Access Compliance Report

Public Rights-of-Way

(Curb Ramps)

Intersection ID: 11981	Main Street: W_6TH_ST	Cross Street: N_CHURCH_ST	Location: W
ADA ID: 41EAE900EFFC	Ramp Type: PerpDiag	Initial Pass/Fail: Fail	Overall Compliance: No
			Severity Score: 13.75

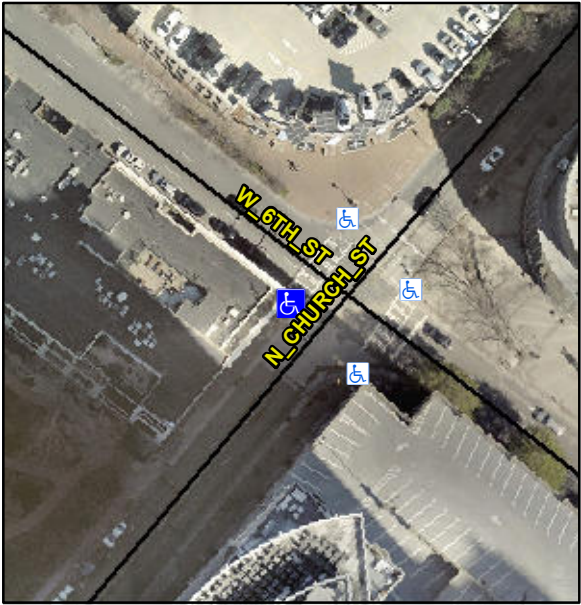
Compliance	Description	Data	Compliance	Description	Data
N/A	Ramp Length (in)	53.0	No	Ramp Slope (%)	10.3
Yes	Ramp Width (in)	54.0	No	Ramp XSlope (%)	3.2
N/A	Flare Type LT	N/A	N/A	Flare Type RT	N/A
N/A	Flare Slope LT (%)	N/A	N/A	Flare Slope RT (%)	N/A
N/A	Flare Traversable LT?	N/A	N/A	Flare Traversable RT?	N/A
N/A	Landing Length (in)	N/A	N/A	DWS Provided?	N/A
N/A	Landing Width (in)	N/A	N/A	DWS Contrast?	N/A
N/A	Landing Slope (%)	N/A	N/A	DWS Length (in)	N/A
N/A	Landing X Slope (%)	N/A	N/A	DWS Full Width?	N/A
N/A	Landing Curb? (Y/N)	N/A	N/A	DWS Offset (in)	N/A
N/A	Shared Landing?	N/A			
N/A	Gutter Ponding?	N/A	N/A	Gutter Slope (%)	N/A
N/A	Gutter Lip Ht (in)	N/A	N/A	Gutter X Slope (%)	N/A
N/A	Painted X Walk1?	Yes	N/A	Painted X Walk2?	Yes
	X Walk 1 Direction	To SE		X Walk 2 Direction	To NE
N/A	X Walk 1 Width (in)	111.0	N/A	X Walk 2 Width (in)	124.0
	X Walk 1 Slope (%)	2.5		X Walk 2 Slope (%)	2.0
	X Walk 1 X Slope (%)	3.1		X Walk 2 X Slope (%)	1.0

N/A	Ramp inside XWalk1?	Yes	N/A	Ramp inside XWalk2?	Yes
	Road Slope (%)	0.2	N/A	Clear Space?	N/A
	Road X Slope (%)	0.9	N/A	Clear Space to XWalk (in)	N/A
N/A	Any Obstructions?	N/A	N/A	Storm Grate/Utility Hazard?	N/A
	Obstruction Type			Storm Grate/Utility Type	
		N/A			N/A
		Yes		Surface Condition? (G/P)	Good

Codes/Mitigation Info/Possible Solution		Field Measurements/Component Compliance			
	Possible Solutions:				
	Remove & Replace Curb Ramp With Two New Directional Ramps or Equivalent.				
	Surveyor Notes:				
	N/A				
	PROW/ADA:				
	R304.2.2, R304.5.3				
Street 1 Name	N CHURCH ST				
Stop Condition-Street 2	Signal				
Street 2 Name	W 6TH ST				
Stop Condition-Street 1	Signal				
Total Cost:		\$	3200.00
